MEMORANDUM TO: Loren R. Plisco, Director
Division of Reactor Projects
Region II

FROM: Ledyard B. Marsh, Deputy Director
Division of Licensing Project Management */RA/*
Office of Nuclear Reactor Regulation

SUBJECT: RESPONSE TO TASK INTERFACE AGREEMENT (TIA) 2002-04 -
SAFETY/RELIEF VALVE OPERABILITY AT EDWIN I. HATCH
NUCLEAR PLANT

NRC INFORMATION NOTICE 2003-01: FAILURE OF A BOILING WATER REACTOR
 TARGET ROCK MAIN STEAM SAFETY/RELIEF
 VALVE

Figure 1 Target Rock Safety/Relief Valve

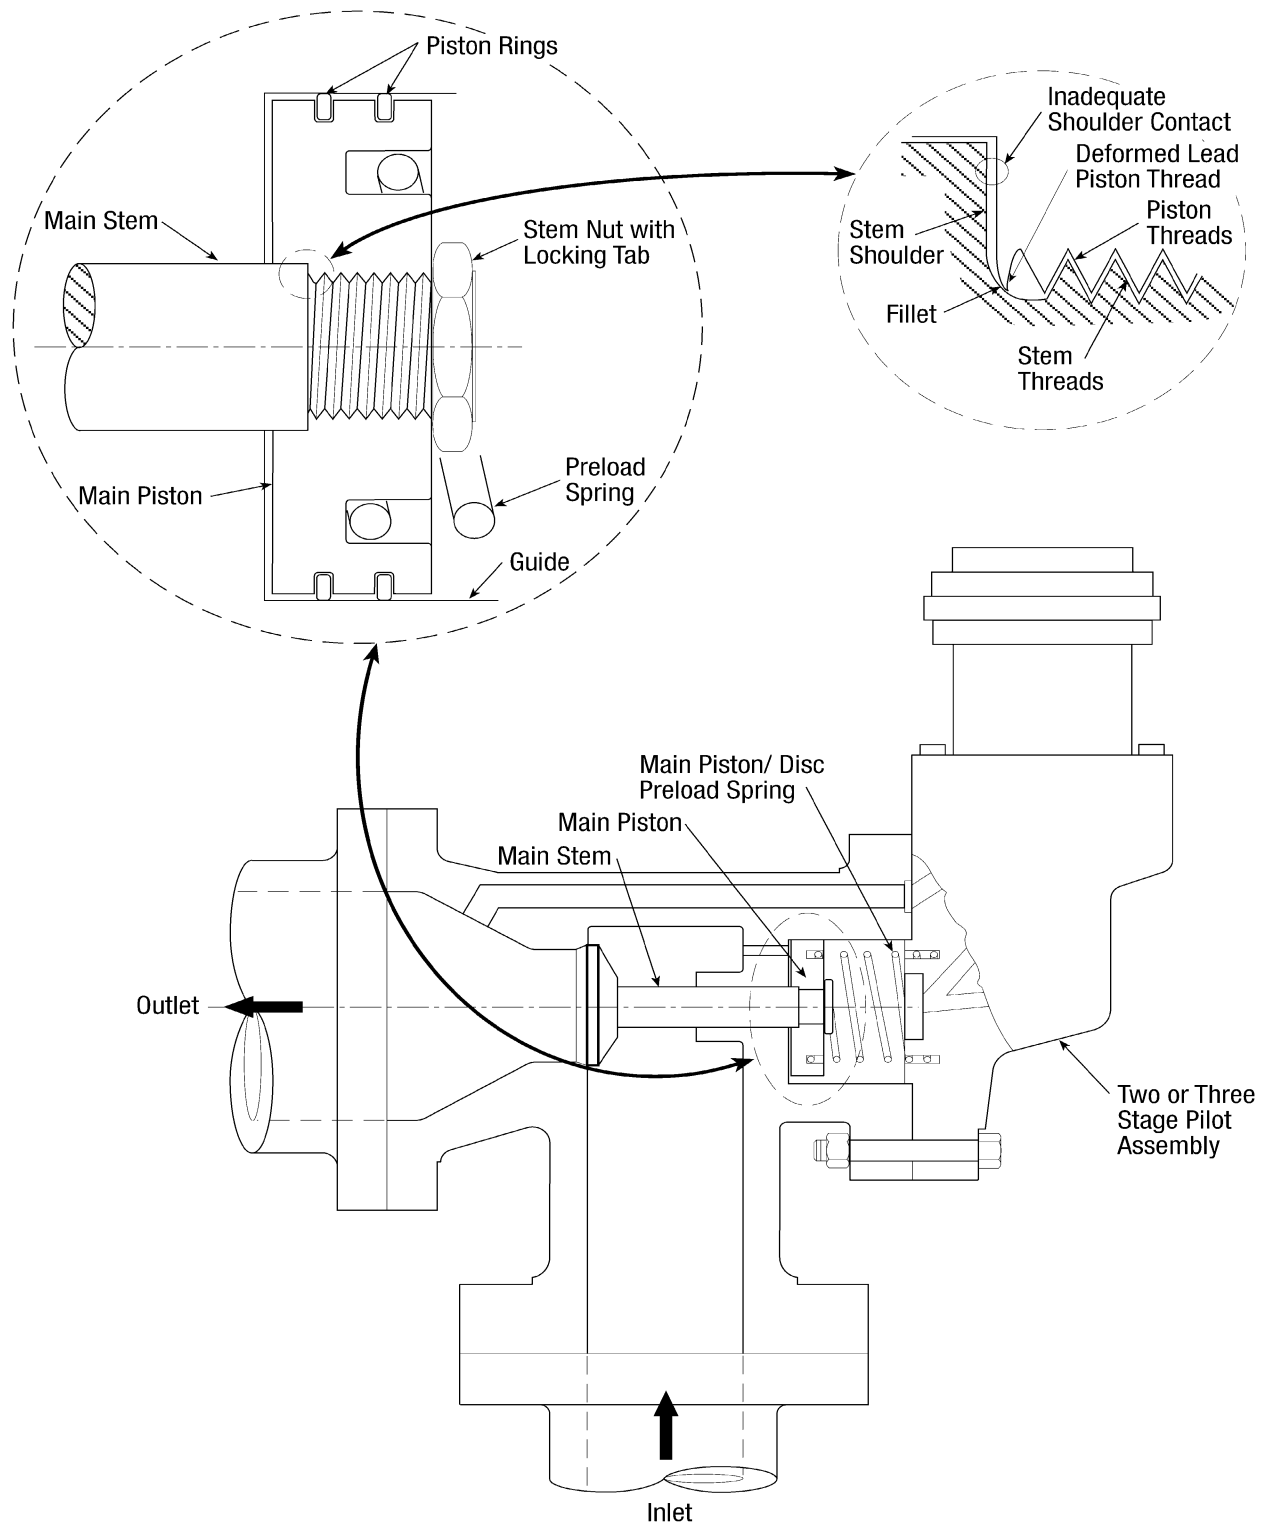
The S/RVs installed in Unit 1 are Target Rock two-stage S/RVs. The main stage valve internals (shown in attached Figure 1) are assembled by screwing the main piston onto the main stem so that the piston moves inside the guide, installing a locking tab washer, and installing the stem nut against the washer's locking tab. The piston is torqued to 100 ft-lbs, the stem nut is torqued to 50 ft-lbs, and the locking tab is bent to capture the stem nut. During the S/RV inspection after the April 2002 shutdown, the failed valve was found to have a .003-inch clearance between the main disc and its seat. When the valve was disassembled, the stem nut and the

piston were found to be loose. The stem nut was removed by hand and the piston was also unthreaded by hand from the stem. However, the threads on the stem were severely damaged. The piston was unthreaded by working it up to the good threads under the stem nut and threading it onto this portion of the stem. The inside of the guide was heavily grooved and was also worn by the piston edge wearing on the guide. The piston was visibly cocked on the valve stem.
